HISTORIC AND DESIGN REVIEW COMMISSION

HDRC CASE NO: 2022-360
COMMON NAME: 206 LAVACA
LEGAL DESCRIPTION: NCB 713 BLK 10 LOT 10
ZONING: RM-4,HE
CITY COUNCIL DIST.: 1
DISTRICT: Lavaca Historic District
LANDMARK: Individual Landmark
APPLICANT: Vicki Yuan/Lake Flato Architects
OWNER: HILL STACEY L
TYPE OF WORK: Demolition of a historic landmark, new construction
APPLICATION RECEIVED: June 10, 2022
60-DAY REVIEW: Not applicable due to City Council Emergency Orders
CASE MANAGER: Hannah Leighner
REQUEST:

The applicant is requesting a Certificate of Appropriateness for approval:

1. Demolish the 2-story, historic structure located at the rear of the lot addressed as 206 Lavaca.
2. Construct a 2-story residential structure in the location of the existing, rear residential structure.

BUILDING ELEVATIONS

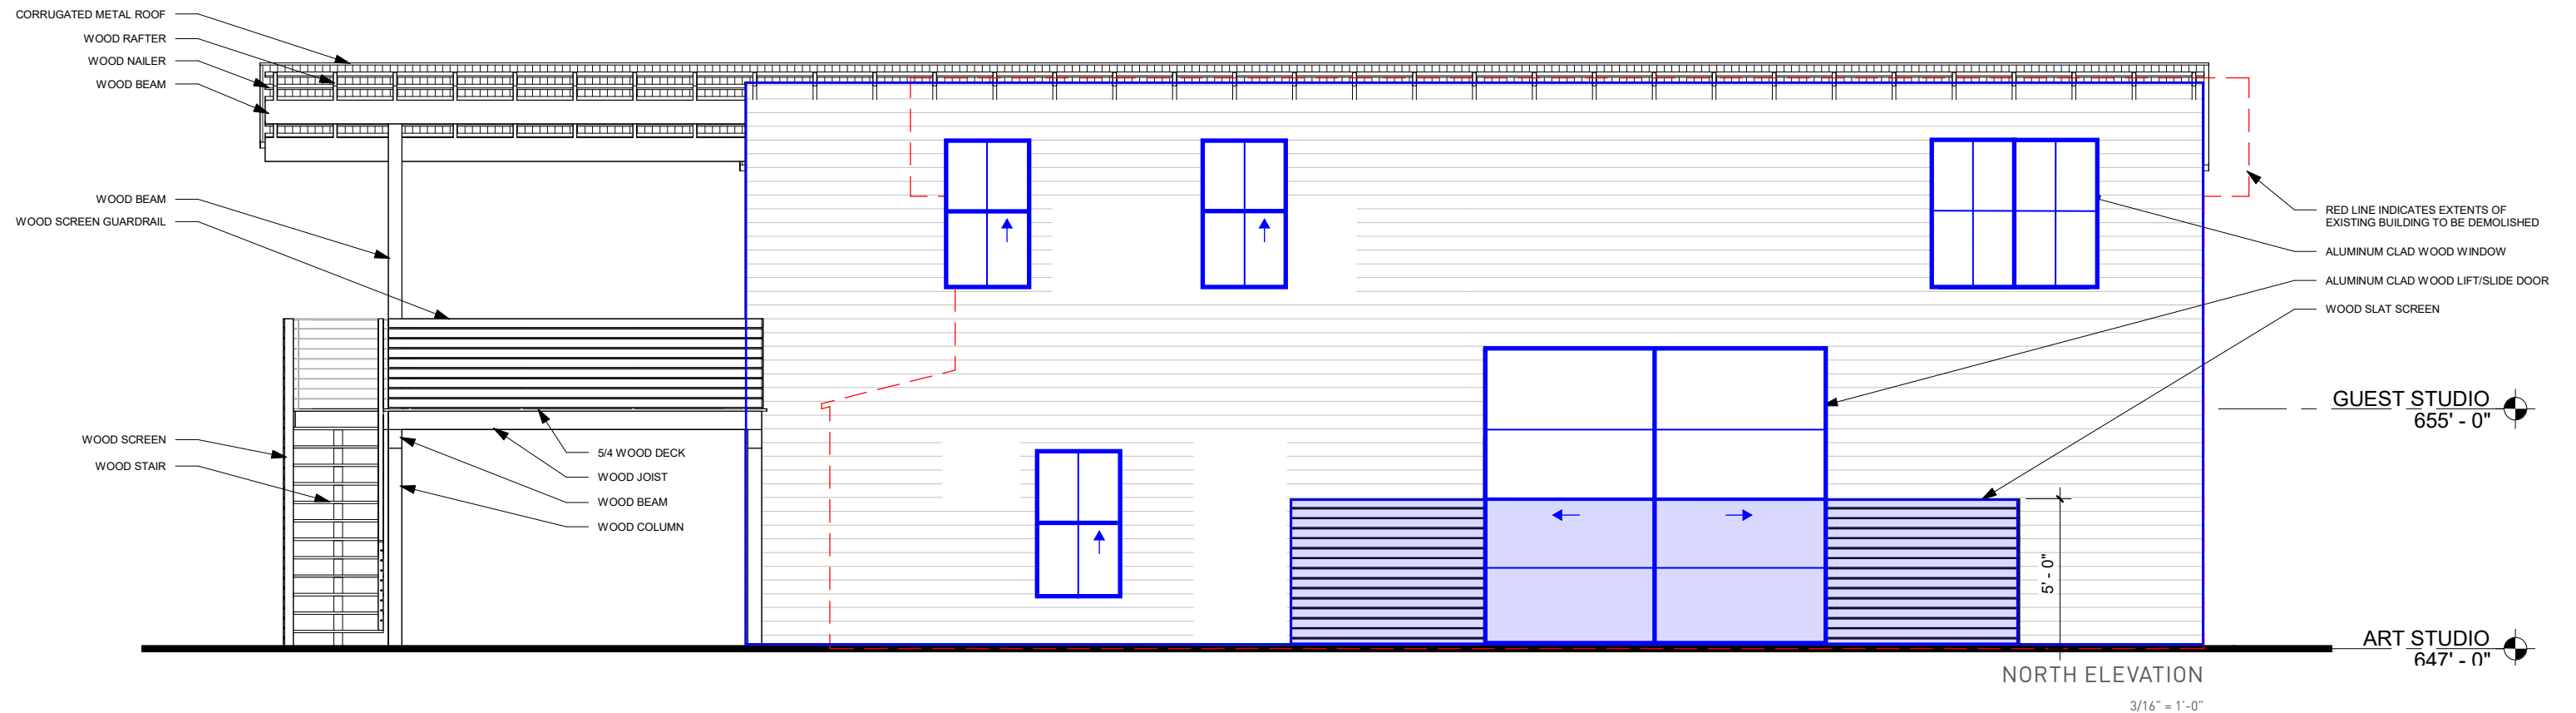
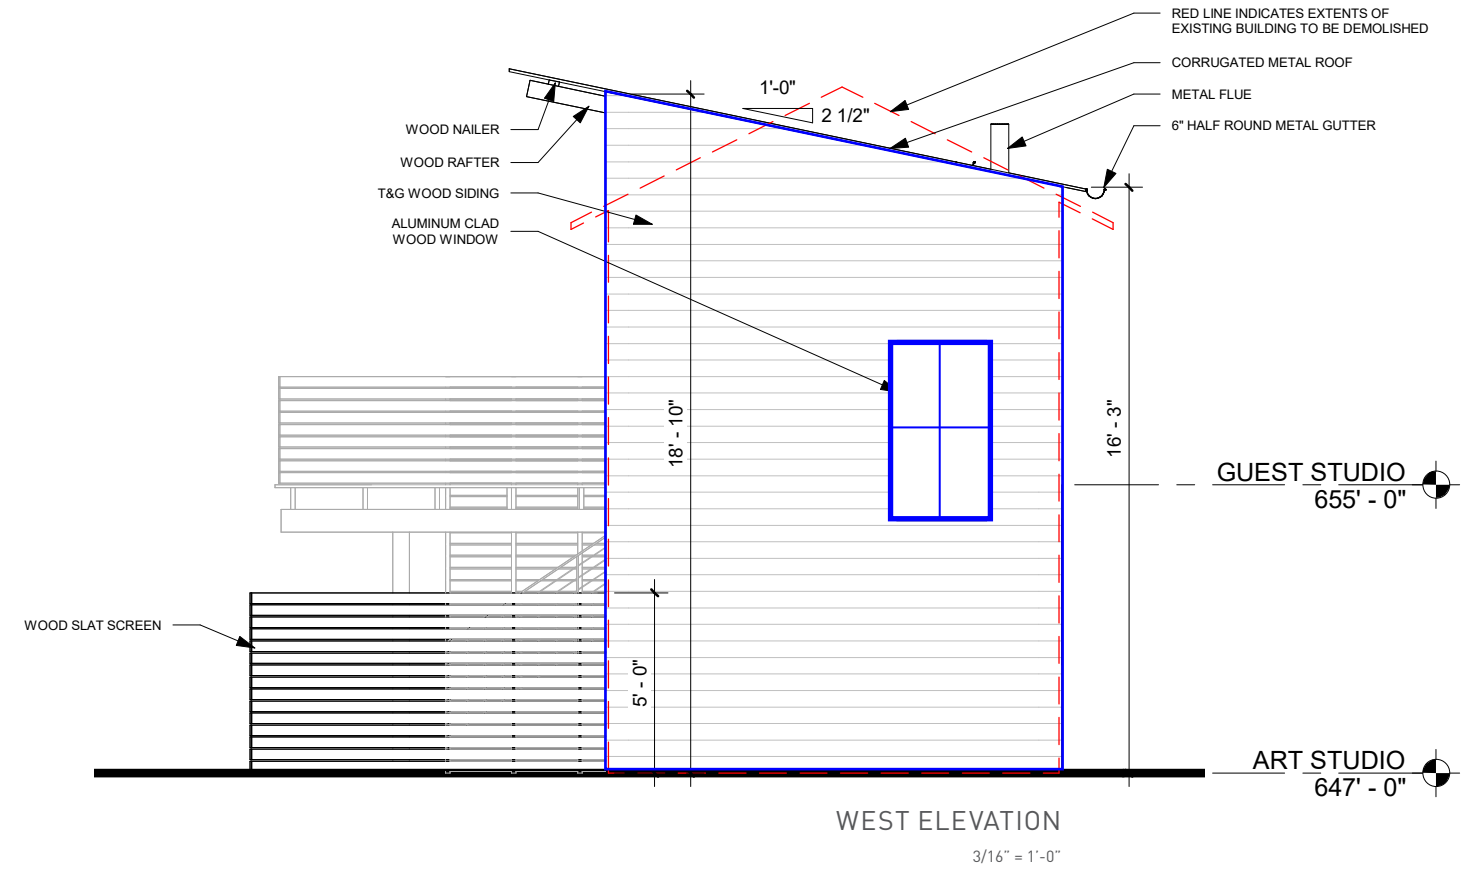
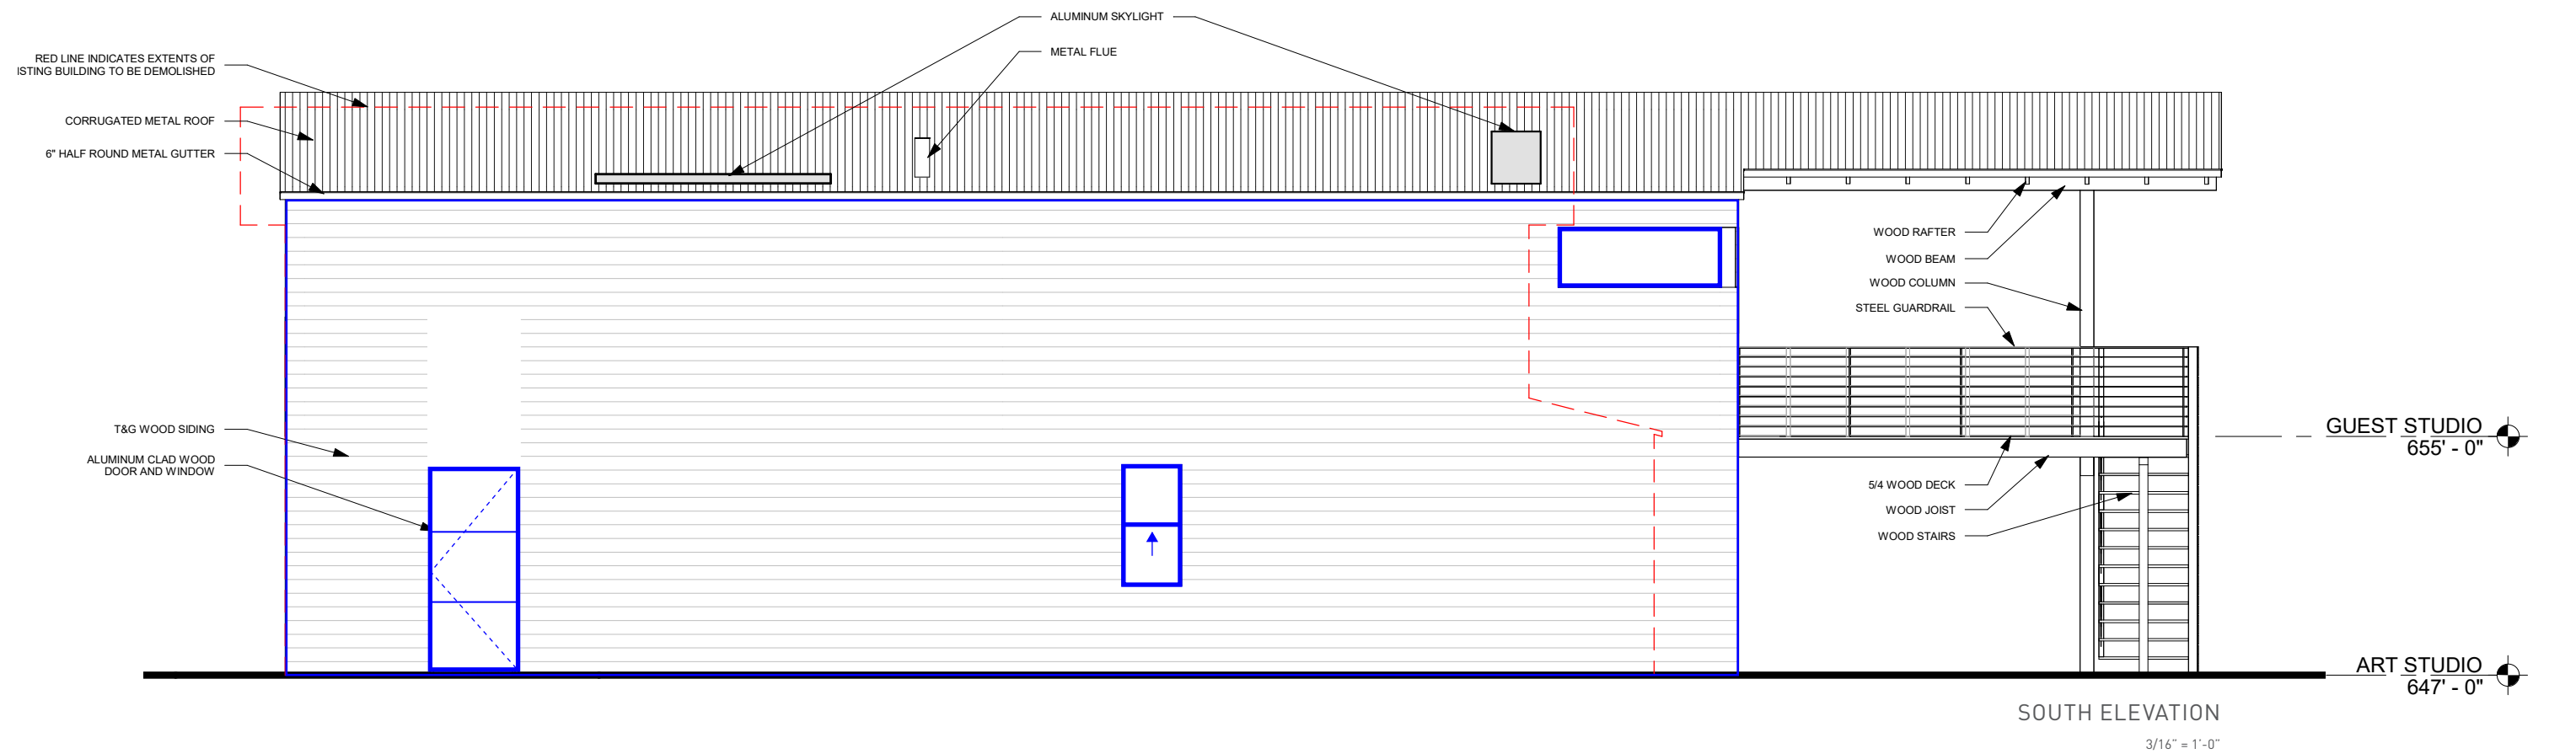
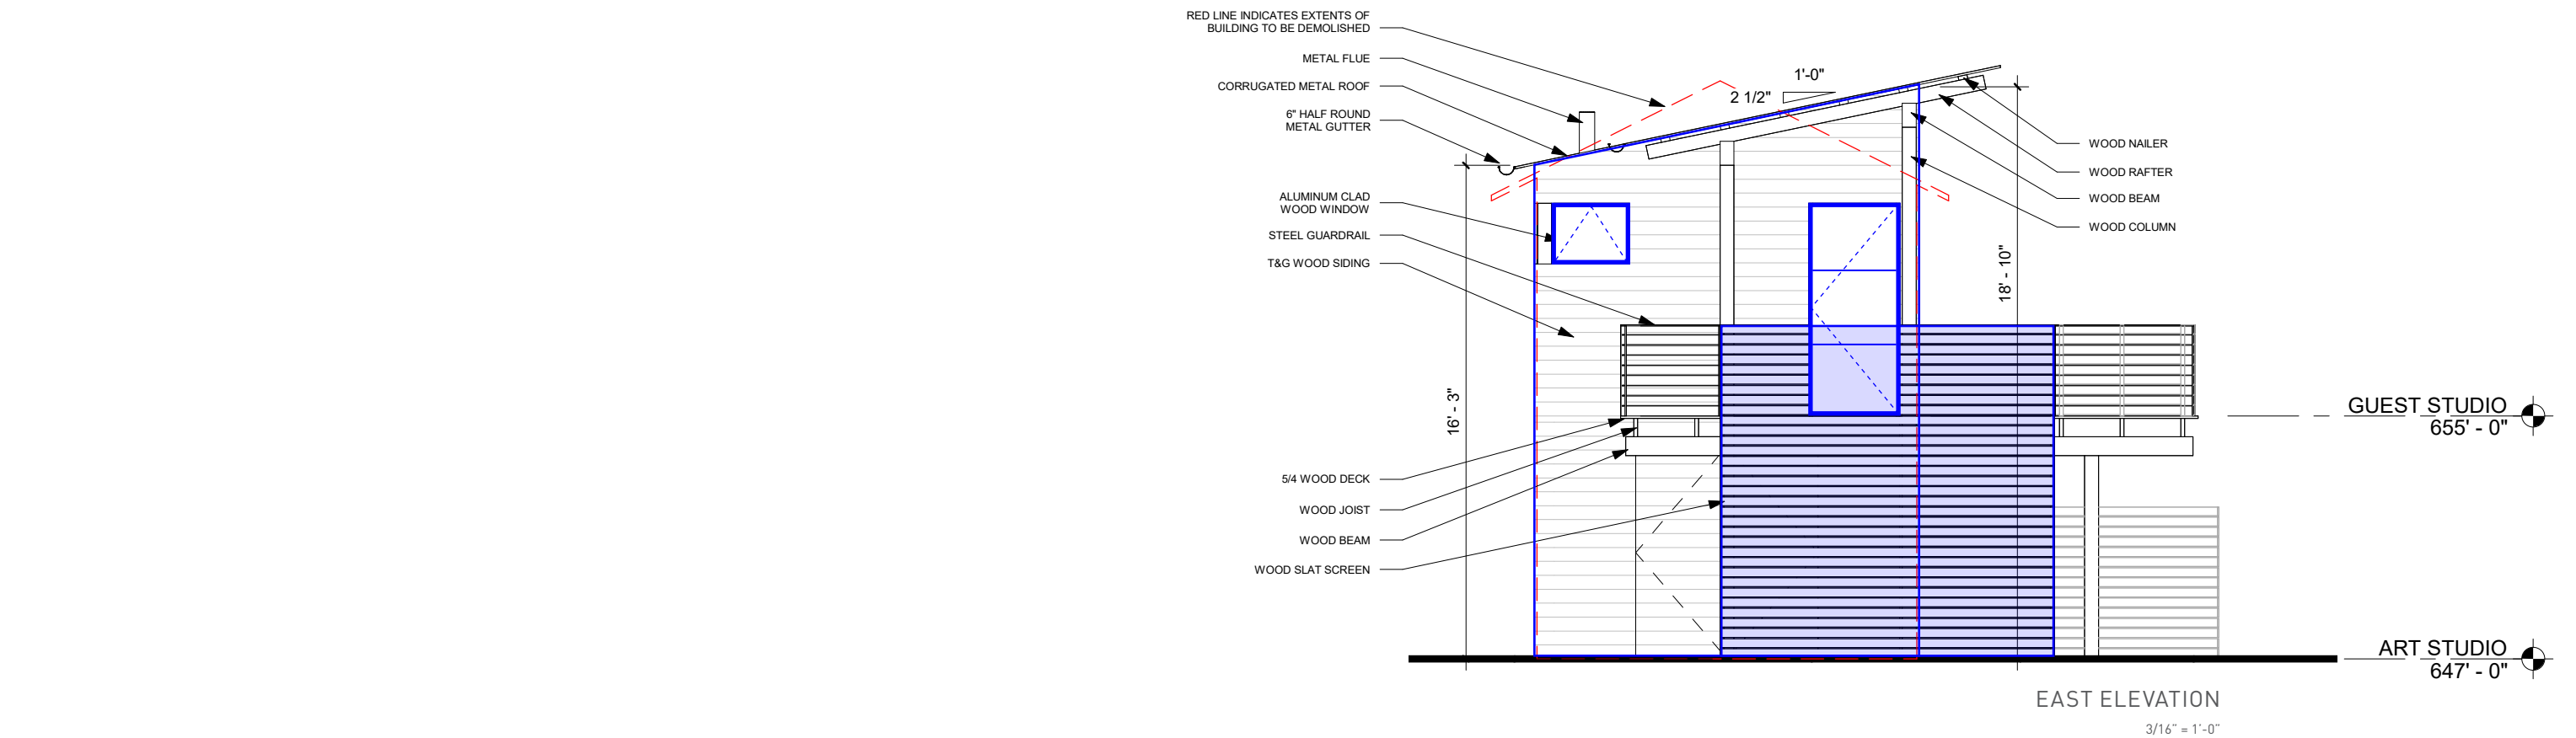
- j. MASSING & FORM – Regarding overall height, the applicant has proposed for the structure to feature a maximum height of 19’. The existing, historic two-story structure to be demolished features a similar height. The applicant has not submitted a massing study with a perspective from the right of way on Lavaca noting the visibility of the proposed new construction. Generally, staff finds the proposed height to be appropriate however the applicant should provide a line of site study prior to approval to confirm this.

- l. CHARACTER (ROOF FORM) – The Guidelines for New Construction 5.A.iii recommends to relate new outbuildings to the period of construction of the principal building on the lot through the use of complementary materials and simplified architectural details. The applicant has proposed to construct a two-story, rear accessory structure that features a shed roof profile. The primary structure at 206 Lavaca, which first appears on the 1894 Sanborn map, features a gable roof form. Generally, the proposed roof form is not found historically within the district; structures with gabled and hipped roofs are, however. Staff finds that the applicant should incorporate traditional roof form, such as a gabled or hipped roof rather than a shed roof form.

- m. CHARACTER (FENESTRATION) – The applicant has proposed windows that feature an overall profile that is consistent with window and door openings found historically within the district; however, the applicant has also proposed square, fixed windows, and a large overhead lifting door, which features a commercial profile and size. Staff finds that all window and door openings should relate to those found historically within the district and be consistent with the Guidelines.

- n. MATERIALS – The applicant has proposed materials that include cedar wood siding, a corrugated metal roof, wood and steel guardrails, and wood columns. Staff finds that the proposed materials should complement those that are original to the primary structure; the use of corrugated metal roofing and steel guardrails is not consistent with the Guidelines, which notes that materials for accessory structures should relate to the period of construction of the primary structure on the site.

- o. WINDOW MATERIALS – The applicant has proposed to install aluminum clad wood windows of traditional sizes and profiles on all elevations. Staff finds that the proposed windows are appropriate, and that the applicant should install the proposed windows to be consistent with staff’s standards for windows in new construction. Grouped windows should be separated by a mullion of at least six (6) inches in width.

2. Staff recommends approval of the proposed new construction based on findings h through p with the following stipulations:
 - i. That the applicant incorporate a traditional roof form, such as a gabled or hipped roof, rather than the proposed shed roof, as noted in finding l.

- ii. That the applicant submit a line of sight study confirming that the proposed new construction will not be visible from the right of way on Lavaca Street, as noted in finding j.

- iii. That the applicant propose traditionally sized window and door openings, that all fixed or non-traditionally sized window openings be modified, and that all grouped windows be separated by a mullion of six (6) inches in width, as noted in findings m and o.

- v. That the proposed materials relate to materials found historically on site and within the district. The use of steel guard rails and corrugated metal roofing should be eliminated. Wood or wood and metal railings with a standing seam metal roof would be most appropriate. Standing seam metal roofing should feature panels that are 18 to 21 inches wide, seams that are 1 to 2 inches in height, a crimped ridge seam and a standard galvalume finish. Panels should be smooth with no corrugation or striations.

FLOOR PLAN - GUEST STUDIO

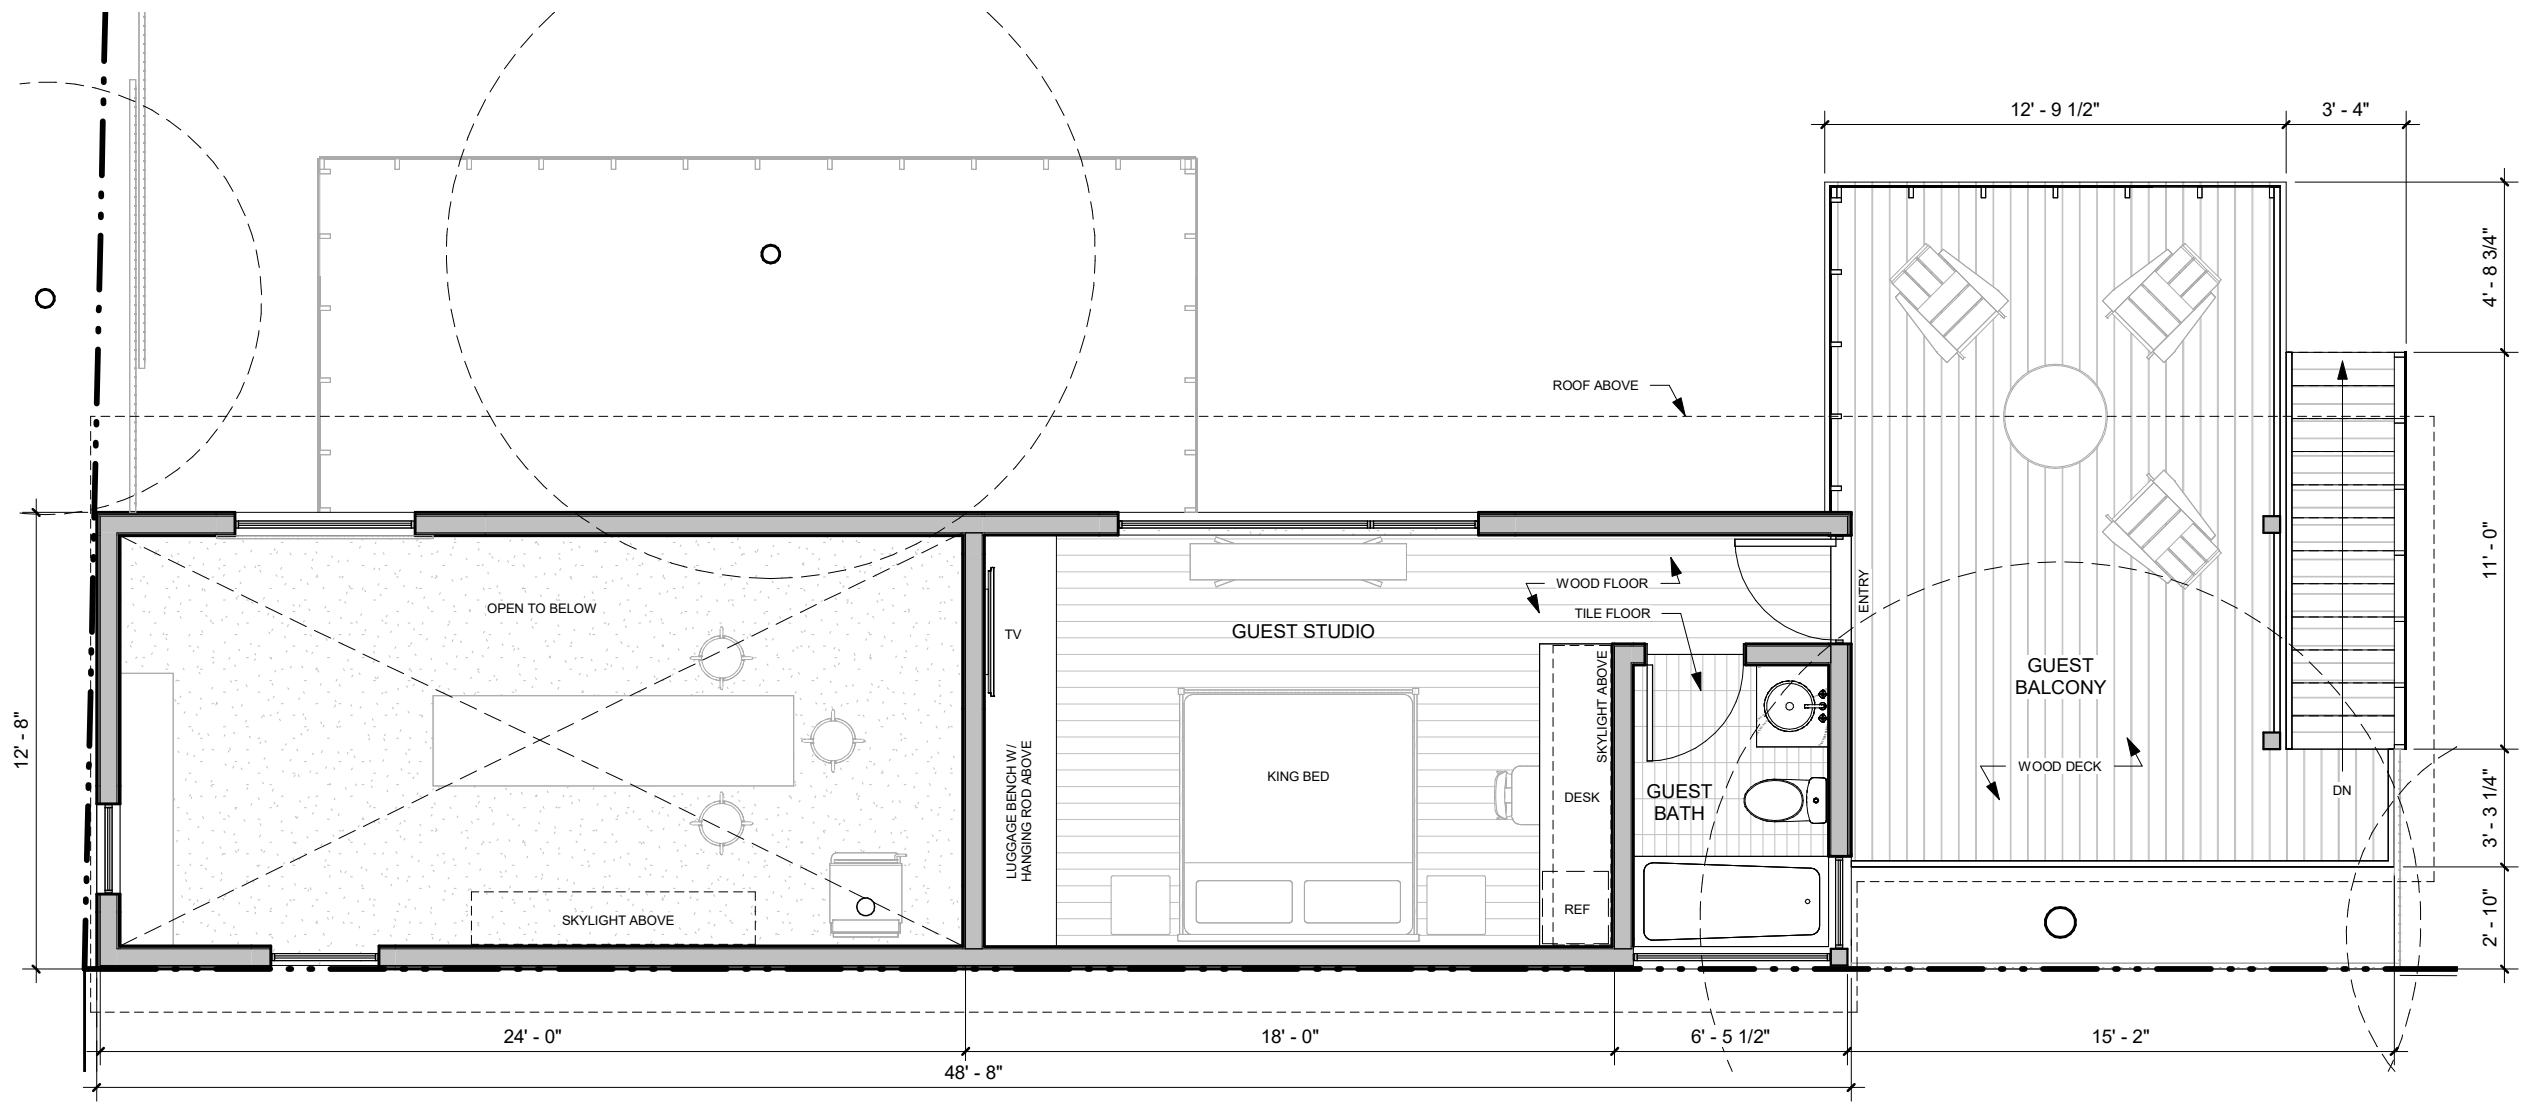
- i. MASSING & FORM – The Guidelines for New Construction 5.A. notes that rear accessory structures are to feature a massing and form that is visually subordinate that that of the primary historic structure in regards to their height, massing and form, should be no larger in plan than forty (40) percent of the primary historic structure’s footprint and should relate to the period of construction of the primary historic structure. The applicant has proposed an overall massing of two stories in height, and a footprint of approximately 650 square feet with a 300 square foot deck to serve as a second floor balcony and carport. The total footprint of the structure is 950 square feet, which is 38% of the footprint of the primary structure at 206 Lavaca, which features an overall footprint of approximately 2,500 square feet. The proposed footprint of the rear accessory structure is generally consistent with the Guidelines.
